5.0 30-36 CLARENDON RD - DESIGN DEVELOPMENT

5.4 PRE-APPLICATION 1 - APRIL 2022

5.4 QUALITY REVIEW PANEL (QRP) - AUGUST 2022

5.4 QUALITY REVIEW PANEL (QRP) - RESPONSES - AUGUST 2022

PROPOSED GROUND FLOOR PLAN

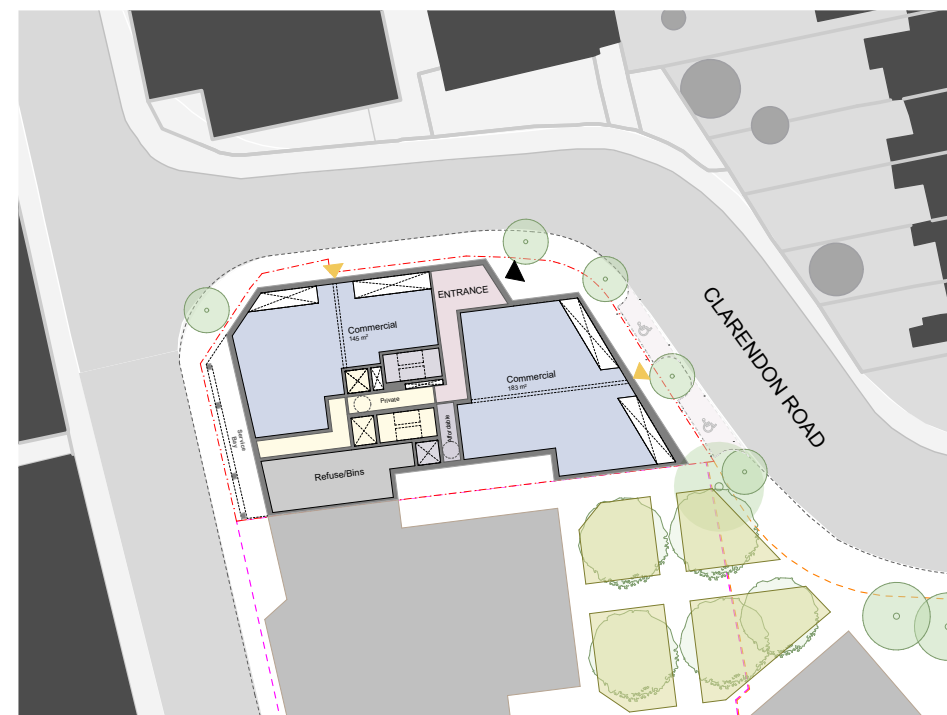
The panel also feels that daylighting of the scheme’s entrance, and the clarity of layout and ease of circulation within this area is problematic and would benefit from a more generous and welcoming treatment.

The panel suggests further consideration is given to the design and layout of the building’s main entrance at ground level. The arrangement of the reception area, corridors and stair / lift access appears overly complex and unresolved.

The entrance approach and ground floor has been opened up and a straight access to the lift area created. The cycle store has been relocated, allowing for a more generous lobby area.

This has been reconsidered as shown on the revised floor plan. There is now a more direct route to the lift area.

AXO VIEW PRESENTED AT QRP

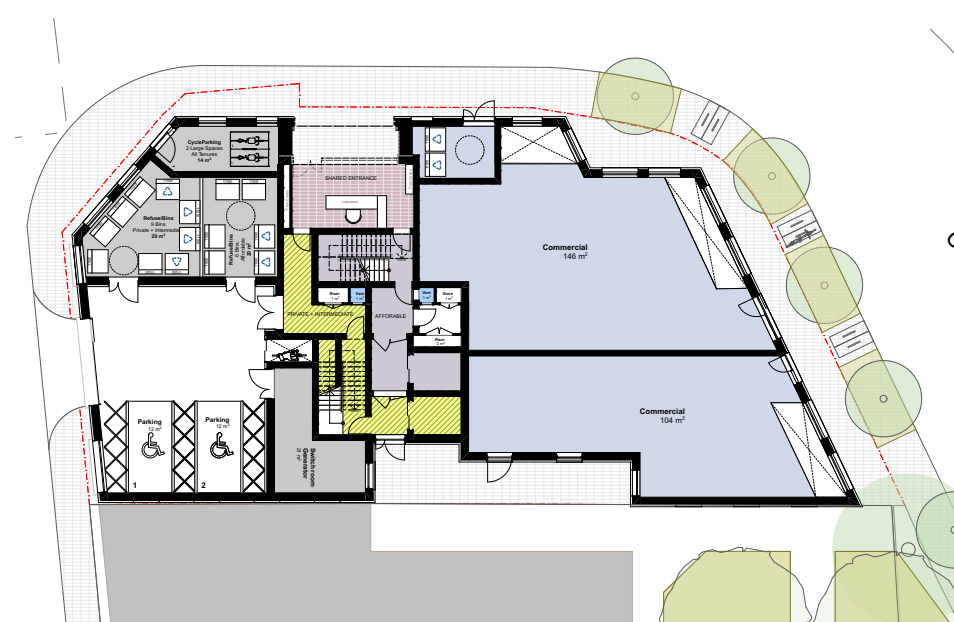
As design work continues, the panel would encourage further work to create greater variety and texture across the scheme’s facades, to improve the appearance of the building, both from a distance and at ground / podium level.

The panel also feels that the verticality of the building might be reduced by revisiting the current window treatment, and further consideration given to, for example, horizontal banding at junctures across its facades. As noted above, a greater horizontal banding and changes to the window arrangement has been introduced to reduce the verticality of the building.

Further consideration has been given to the elevational treatment of the building, particularly the southern elevation, where an increased rhythm has been introduced. In order to break up the vertical emphasis horizontal banding has been introduced, along with different materials and fenestration,

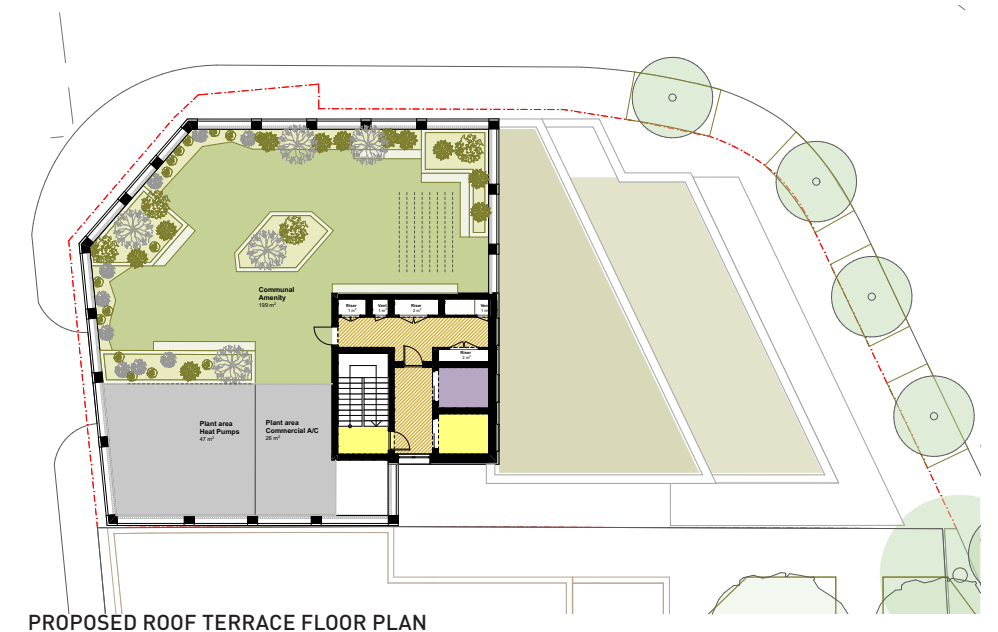
The aim should be to lighten the appearance of the building, which the panel feels is currently quite heavy. The panel points to the brick textures and colours used in other recently completed buildings in the area as reference points.

The Design Team has given further consideration to the choice of materials in order to lighten the appearance of the building. This has included looking at materials being used in surrounding developments, notably the Clarendon Gas Works scheme for St Williams.
